August 13, 2004

Subject: Evaluation of Potential Impacts on Hydrology and Water Supply
THP No. 1-04-055 SON and Proposed Negative Declaration TCP No.04-533
Roessler/Zapar Inc. THP/Conversion, Annapolis, California

Figure 3.8.—Relationship of Median Infiltration Rate Classes with Total Organic Cover (%), Edwards Plateau, TX (Thurow, 1985).

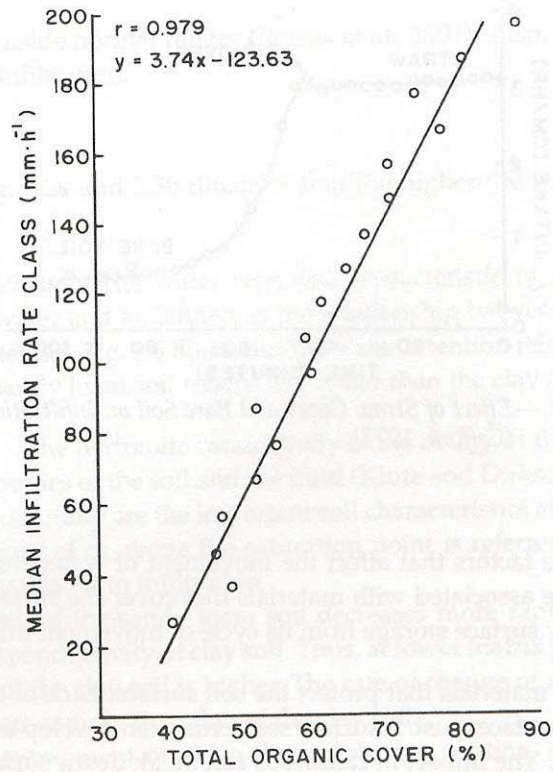
From a water supply perspective, the runoff discrepancy may translate into significantly reduced water availability for groundwater recharge (i.e. instead of 50-percent of annual rainfall being available for infiltration and “contributing to low-flow based flows in the lower reaches of Little Creek” (Erosion Control Plan, page 5), only 37-percent will be available for infiltration. Another problem is that these figures only reflect existing watershed conditions. In order to properly quantify the impacts of the project on hydrologic conditions, one needs to develop a detailed water budget comparing the perceived gains in available soil moisture as a result of logging against the retained vegetation water demands (evapotranspiration) and infiltration potential from the altered substrate. The relationships between groundcover type and infiltration potential are well understood in the scientific and water resources engineering communities as exemplified in the attached Figures. In general, these figures³ demonstrate:

- Increased organic cover leads to increased infiltration rates;
- Areas covered in vegetation have higher infiltration rates than cultivated areas; and
- Forested areas commonly have higher infiltration rates than grasslands.

These bullets are in direct opposition to the claim in the Erosion Control Plan that states the proposed vineyard will have an infiltration rate similar to forested conditions.
